DIABLO CANYON UNIT 1
INDEPENDENT DESIGN VERIFICATION PROGRAM
ELECTRICAL EQUIPMENT ANALYSIS
ITR #33
REVISION 0

Docket No. 50-275
License No. DPR-76

INTERIM TECHNICAL REPORT

ELECTRICAL EQUIPMENT BY ANALYSIS

Figure 4
 Design Analysis Dynamic Model For
 Hot Shutdown Remote Control Cabinet

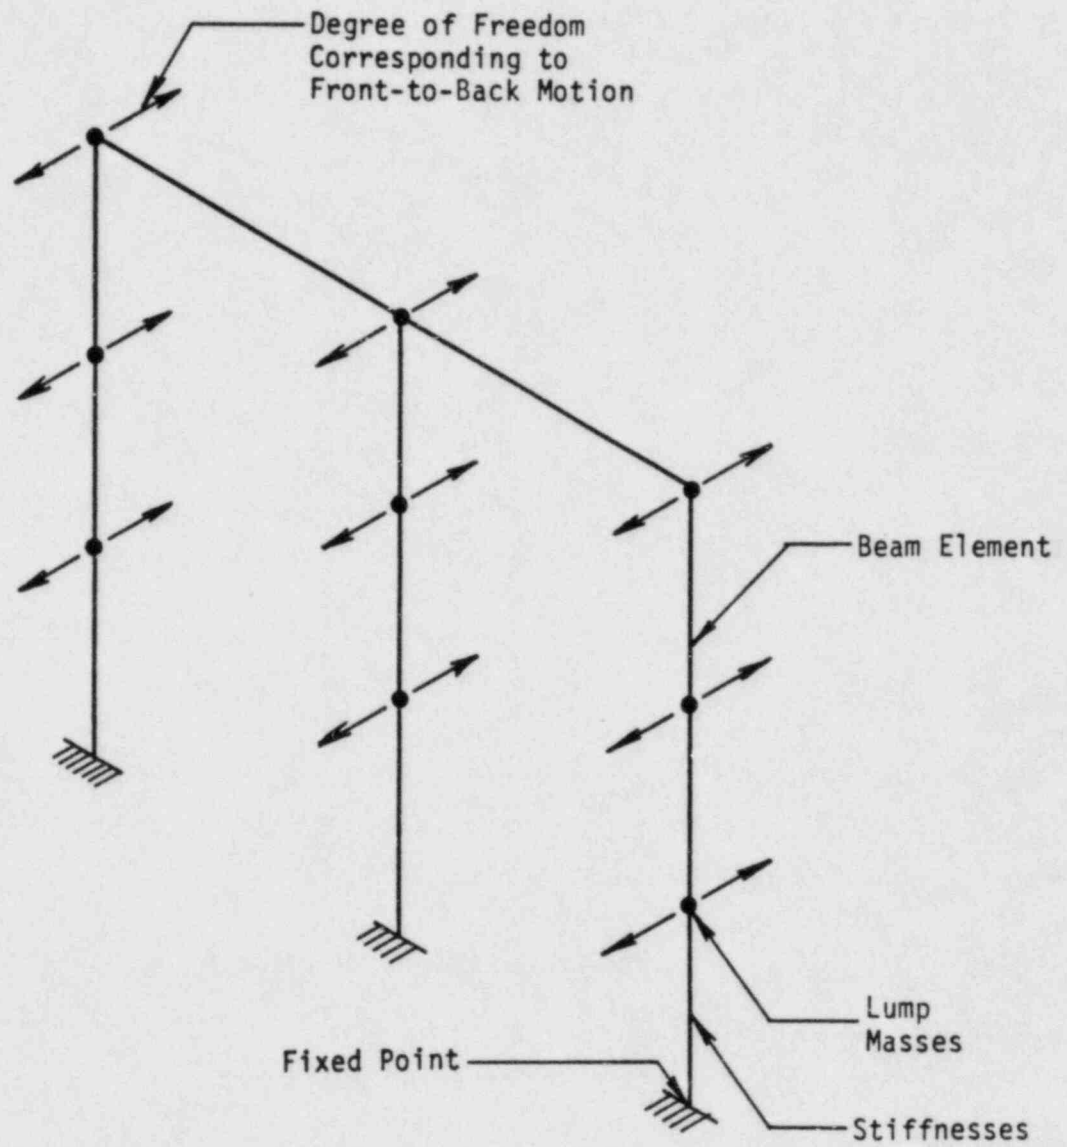
Both the verification and design analyses of the overall cabinet structure considered the cabinet's front-to-back direction to be the most flexible direction. However, the methodologies used to represent the front-to-back characteristics differed: while the verification analysis used a single degree of freedom model based on a reduced cross-section of the cabinet, the design analysis used a lump mass and beam element model with nine lumped masses.

The verification analysis used a single degree of freedom model using a stiffness calculated from a reduced cross section. The total mass of the cabinet was lumped at the center of gravity. The design analysis used a more refined model with nine distributed lump masses.

EOI 1087 reports differences of greater than 15% between the independent analysis results and the design analysis results. This EOI was subsequently closed because the IDVP showed all stresses to be below the allowable stresses.

Main Annunciator Cabinet Assembly
 Elevation View Looking West
 (shown without doors)

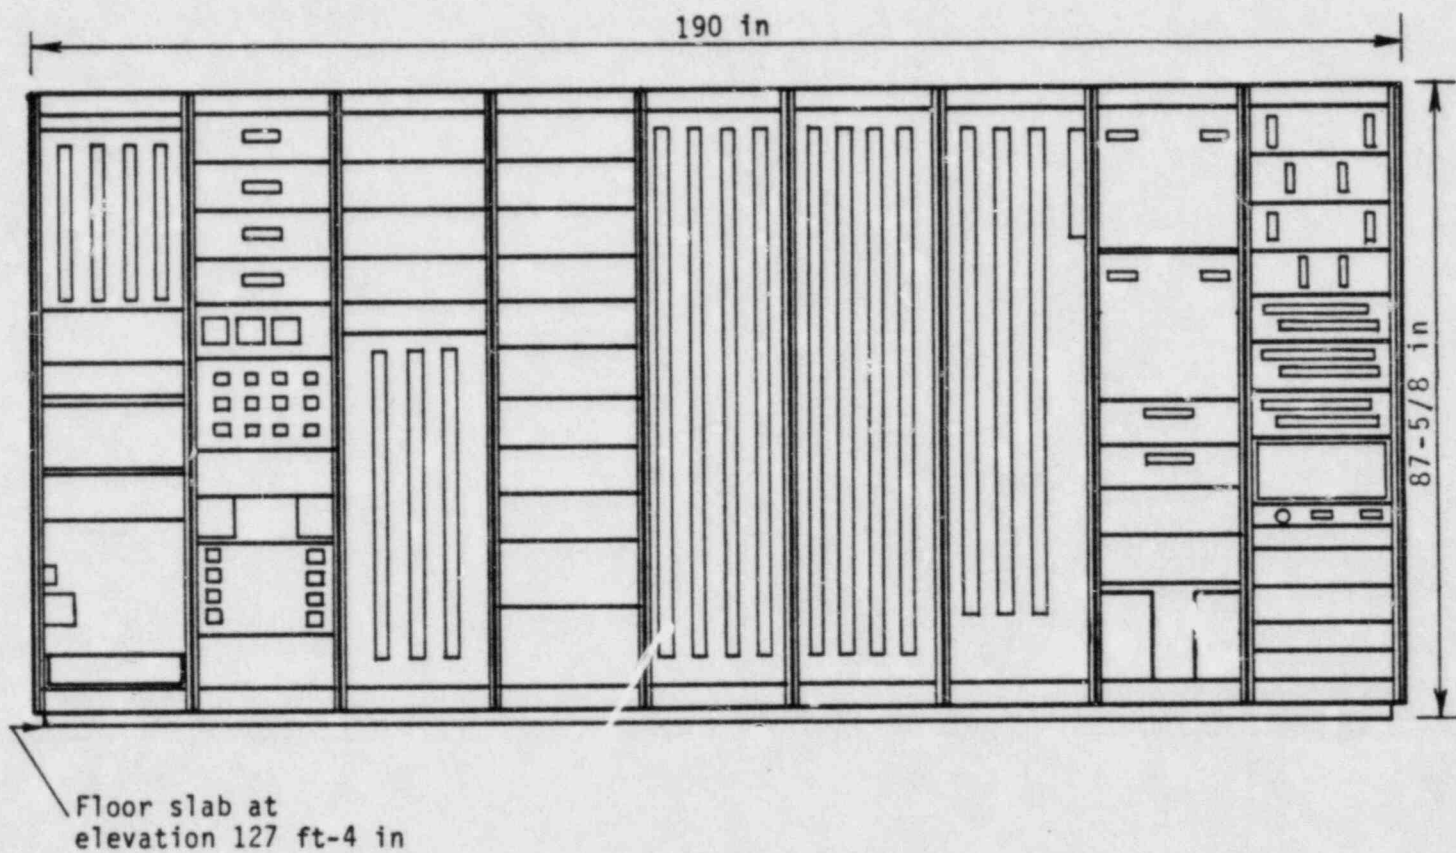
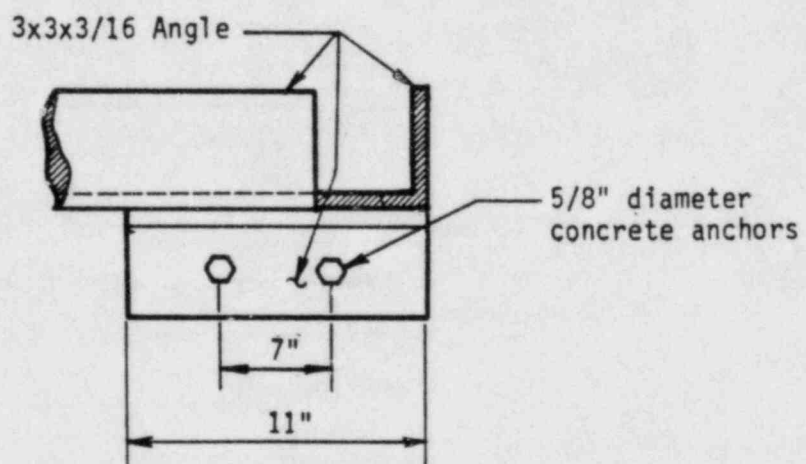
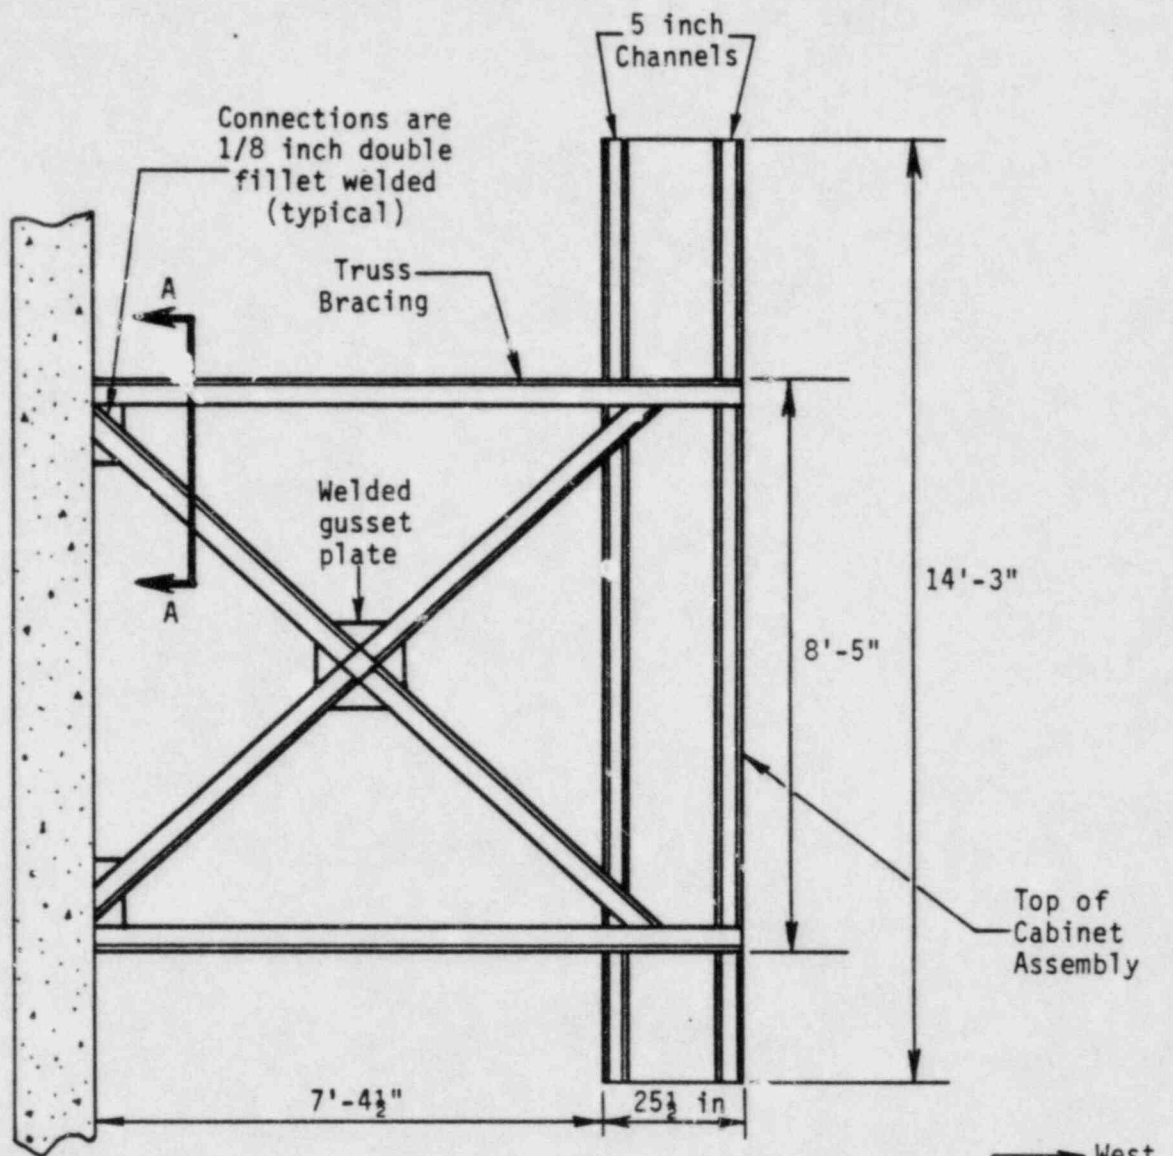
The verification analysis computed loads and stresses at the following key areas and compared them to the allowables. The results show that the bracing concrete expansion anchor loads and the interior cabinet member loads for North-South loading exceed allowables (ECI 949).

The difference between the design analysis and the verification analysis is that the design analysis assumed that the cabinet assembly was rigid in the side-to-side (North-South) direction. Thus, the design analysis did not account for the effects of the amplified structural response in the side-to-side (North-South) direction.

The design analysis did not report loads and stresses in the upper truss bracing. The verification analysis of the connection between the truss bracing and the wall showed that when the structural response in the side-to-side (North-South) direction was accounted for, the expansion anchor bolt loads exceeded the allowable (EOI 949).

EOI 949 was issued because the loads (determined by the IDVP) on the concrete expansion anchors securing the truss bracing to the wall exceeded the allowable. In addition, the design analysis assumed that the cabinet was rigid in the side-to-side direction. The concrete expansion anchor loads exceeded allowables because the design analysis did not examine the side-to-side motion based on this rigidity assumption. The IDVP found the side-to-side natural frequency of the structure to be in the flexible range.

PGandE is modifying the main annunciator cabinet assembly to make the cabinet assembly rigid in the side-to-side direction. EOI 949 is described as an Error Class A or B pending IDVP verification of the modification.

Figure 7
Verification Analysis Model
for Main Annunciator Cabinet

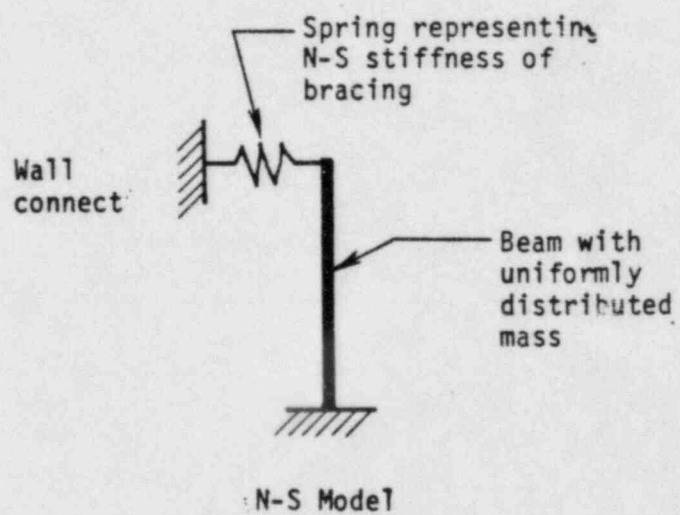
The natural frequency of the cabinet assembly in the North-South directions was calculated as 7.6 hertz.

Seismic accelerations were chosen from Hosgri response spectra at 4% damping to correspond to the IDVP natural frequencies. Since there are no response spectra available for elevation 127 feet, acceleration values were linearly interpolated between spectra values for elevations 115 feet and 140 feet. The interpolation also considered the height of the truss bracing attachment point. The spectra used in the verification analysis are listed in Appendix C.

An equivalent static method was used to determine the loads and forces from the 6.38g North-South seismic accelerations. These loads and forces were then used to calculate stresses at key areas (see Table 3). The calculated stresses were then compared to the allowables.

Figure 8
Design Analysis Computer Model

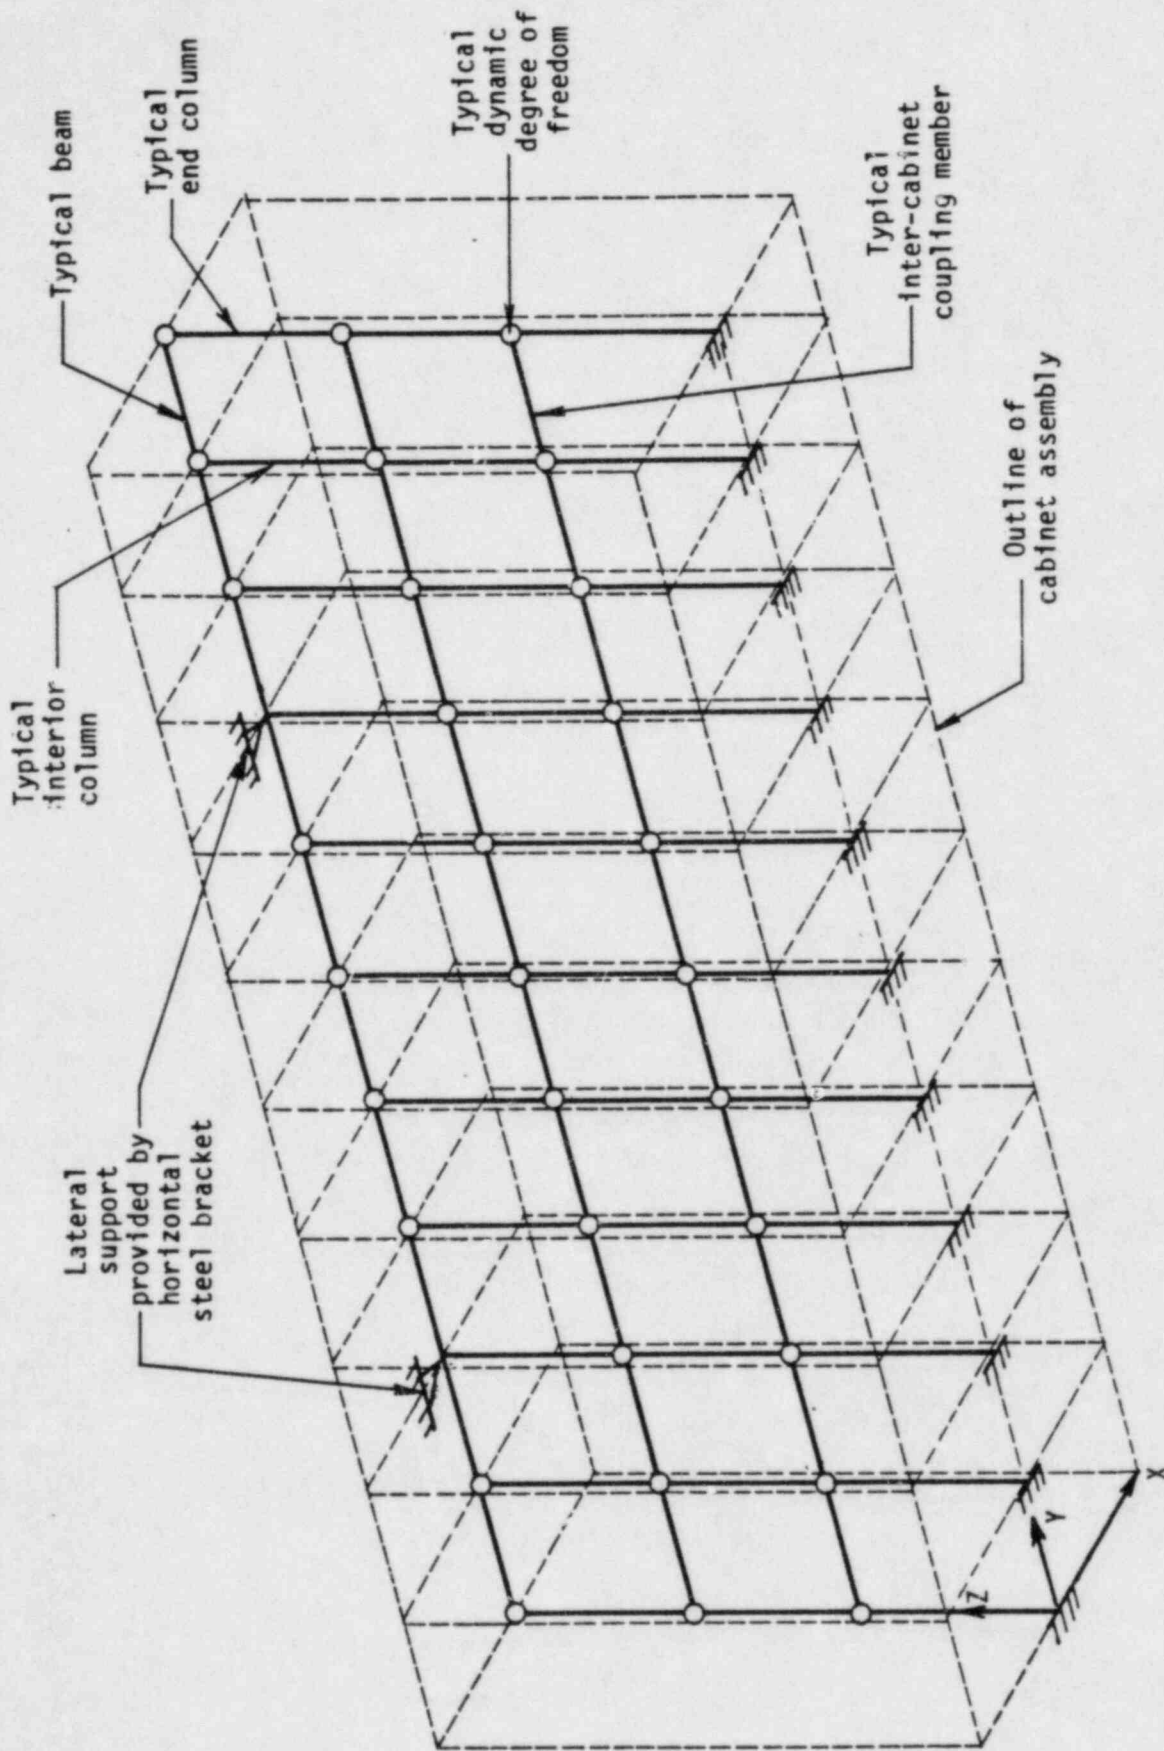
The design analysis of the main annunciator cabinet assembly modeled the dynamic characteristics using a lump mass and beam element computer model (Reference 13). The model, shown in Figure 8, only accounted for the front-to-back (East-West) motion of the cabinet assembly. The design analysis concluded that the cabinet assembly is rigid in the side-to-side direction because the doors were assumed to provide a substantial stiffness contribution in that direction when they were closed.
